Village of Lions Bay
Water Storage Facilities Replacement

March 14, 2018

ADDENDUM # 2

S-001

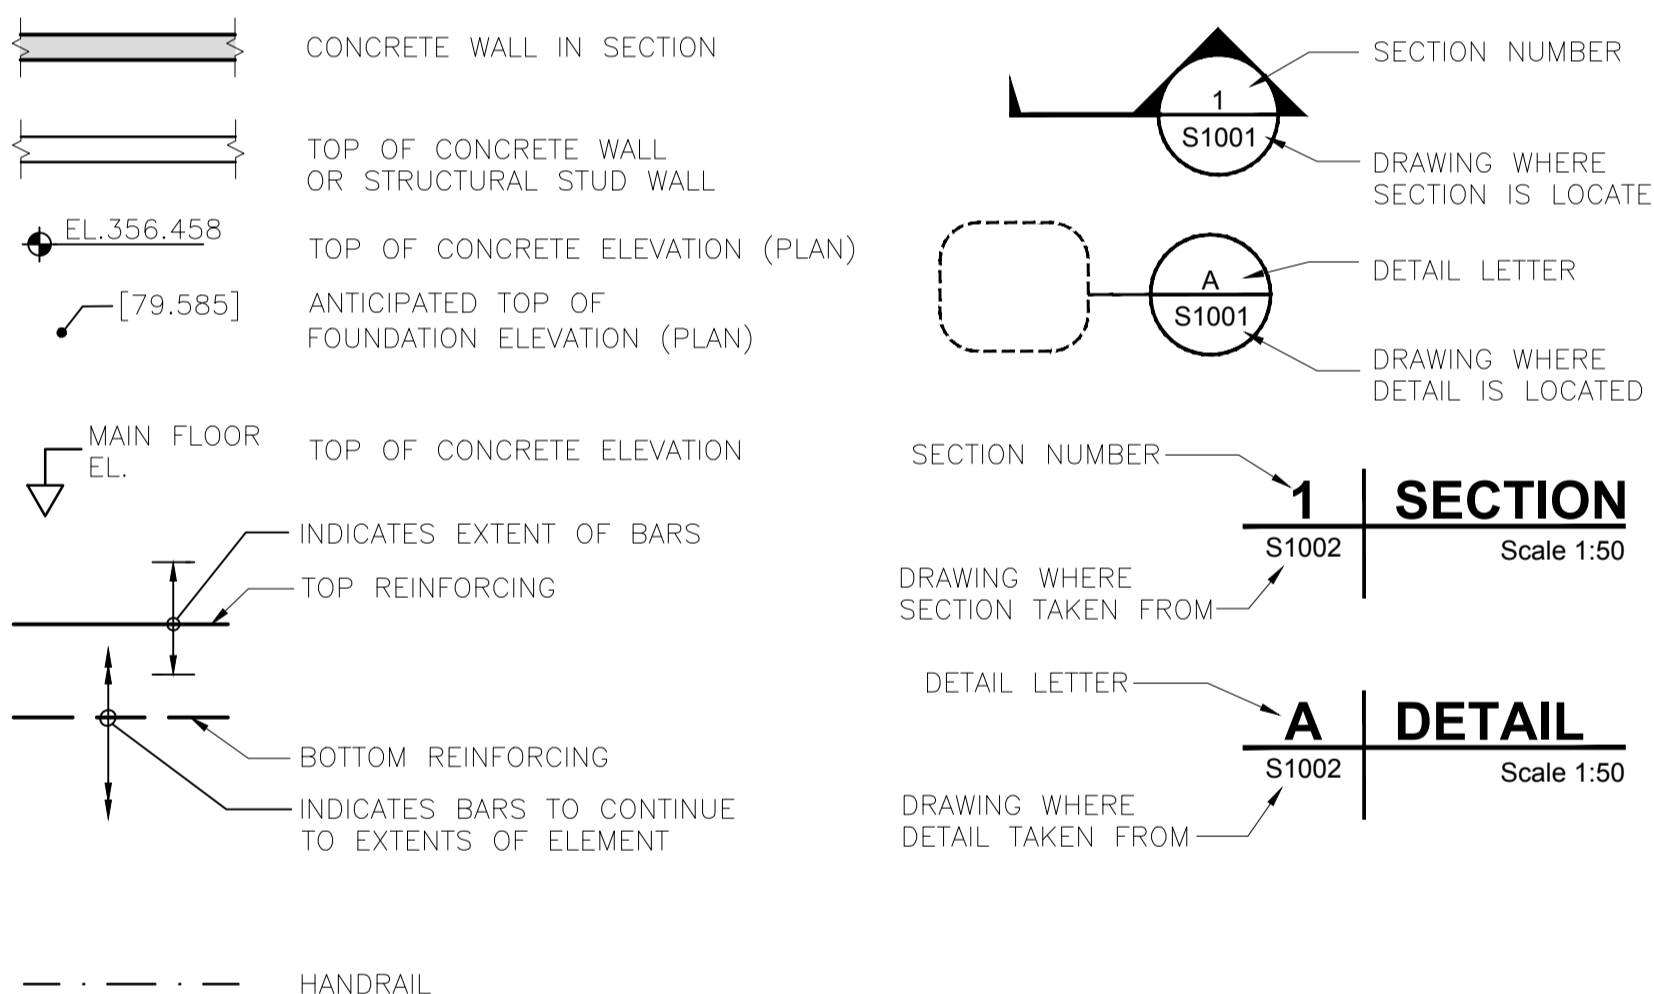
Question 2. Drawing S-001 General Note 13 indicates a formliner shall be required for interior tank surfaces. Please review and confirm that formliners are not required when prefabricated steel faced forms are used in accordance with Specification Section 03 10 00, paragraph 2.1.6.1.

Question 3. Drawing S-001 Pre-Stressed Tank General Note 2 lists the minimum required concrete strength and water cement ratio for the various parts of the proposed prestressed concrete tank. Please note that these values differ from the values given in section 33 16 13.16.2.1.5 and 2.1.6 of the project specifications. In order to avoid potential confusion, please confirm that the minimum strength and water cement ratio values noted in the project specifications should be used.

Answer 2: The liner is for cast-in-place tank option only, not for pre-stressed post tensioned tank.

Answer 3: For cast-in-place concrete, the compressive strength listed in on drawing S-001 and the compressive strength listed in the specifications is meant to be consistent. It should be same for post tensioned concrete. Drawing S-001 has been re-issued as part of this addendum.
